BFX-AT100

May Mass production inspection

Model Name: BFX-AT100

Document Version: ALT_STB_MP_CSMTINS_001

- No power on.

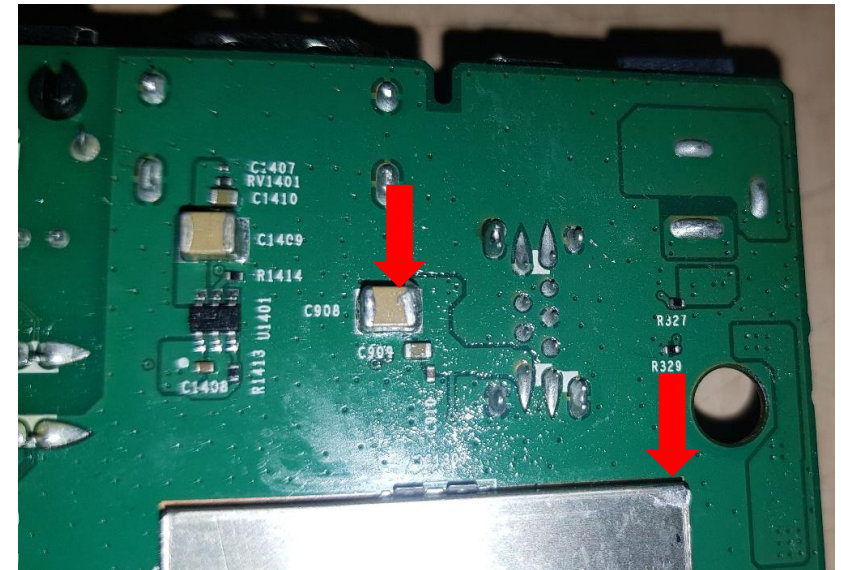
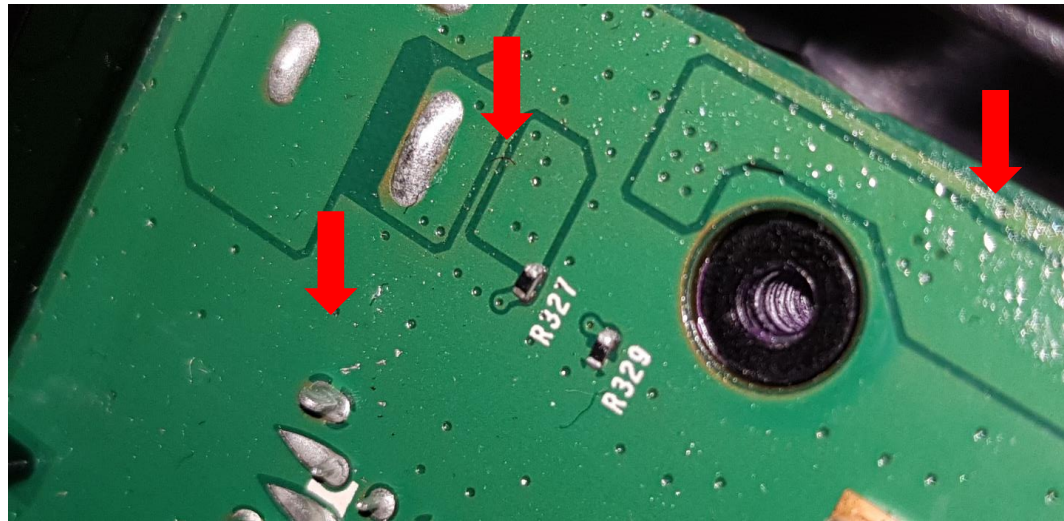
- Defect carton Q'ty : 1pcs / 500pcs
- Defect rate : 0.2%
- SN : 2149688001202001050551
- SKB quality team defined that DoA(Defective On Arrival) is critical issue on incoming inspection.
- ALT get the SKB waiver to avoid lot reject
 - ALT replace to defective PCBA : 2149688001202001050551 to 2149688001201999000011
 - > Changed the mac address as original one.
 - Additional sampling 500 units tests were conducted at ALT cost to find the same defect
 - > No additional defects founded.

- No power on.
 - Action item
 - FXN should be submit 8D report until 26JUNE2020
 - Find the root cause and screen factory stocks – PCBA and raw material
 - Report the factory screening result
 - Report the rework STANDARD
 - Provide FXN rework standard
 - Provide factory rework history of 20k delivered on 26 March Lot. Including 2149688001202001050551.
 - ALT Comment
 - this PCBA condition is not meet IPC-610 class 2 standards.
 - According to the manufacturing specification of BFX-AT100, factory should comply the IPC-A-610 Class 2. Acceptable Condition.
 - Solder webbing. : All class of IPC-A-610 is define the defect.
 - MLCC on the bottom soldering condition : (Please refer to the next page)

- No HDMI output

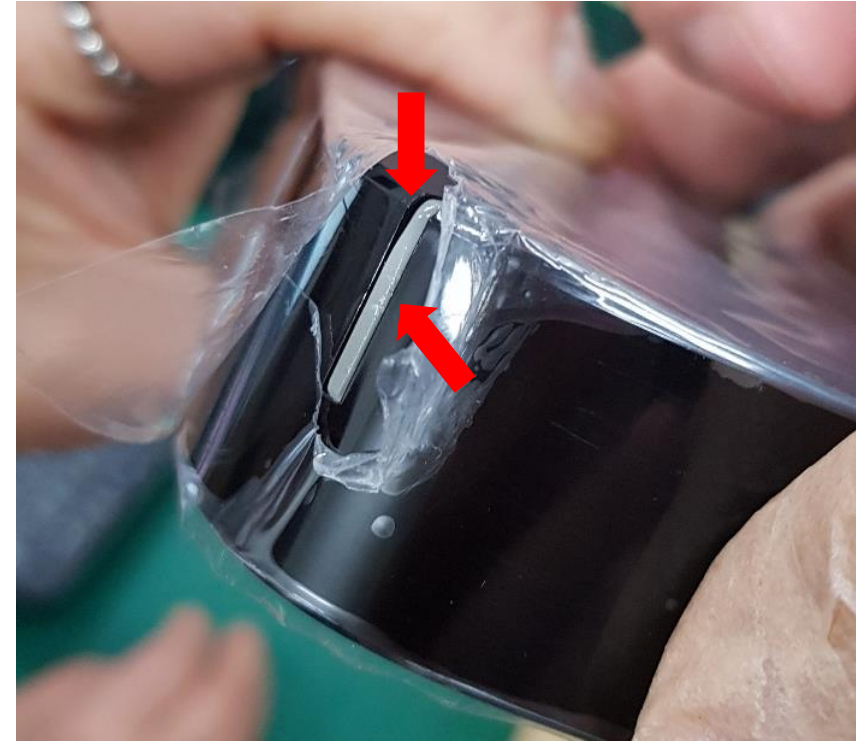
- Defect carton Q'ty : 1pcs / 500pcs
- Defect rate : 0.2%
- SN :
- ALT get the SKB waiver to avoid lot reject
 - ALT swap the defective STB : 2149688001202003044082 to 2149688001201999000017
-> Changed the mac address as original one.
 - Additional sampling 500 units tests were conducted at ALT cost to find the same defect
-> No additional defects founded.

- FXN should be submit 8D report until 26JUNE2020
 - Find the root cause.
 - The cause should be included why not detected defect in the test process in factory

- Giftbox damaged

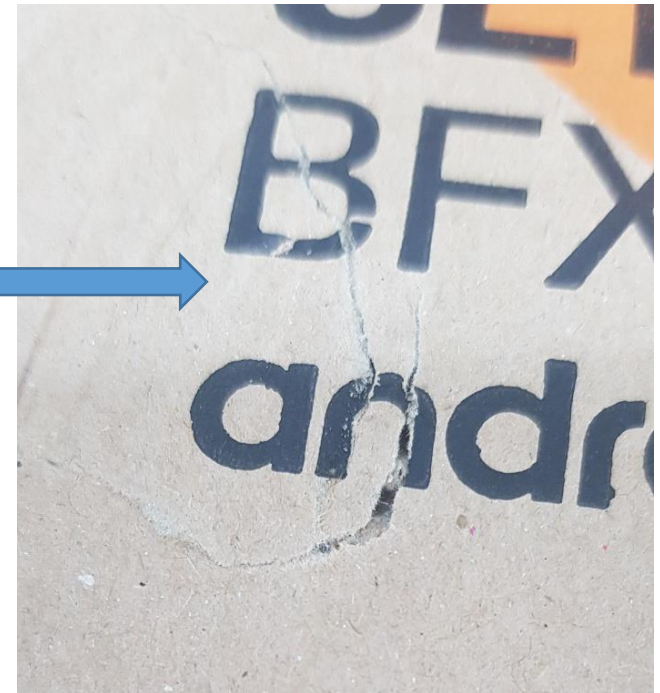
- Defect carton Q'ty : 1pcs / 500pcs
- Defect rate : 0.2%
 - SN : 214968800120200344157
 - The gift box top of the model name area, was torn
- Action item
 - FXN should be submit 8D report until 26JUNE2020
 - Find the root cause.
 - Provide the preventive action
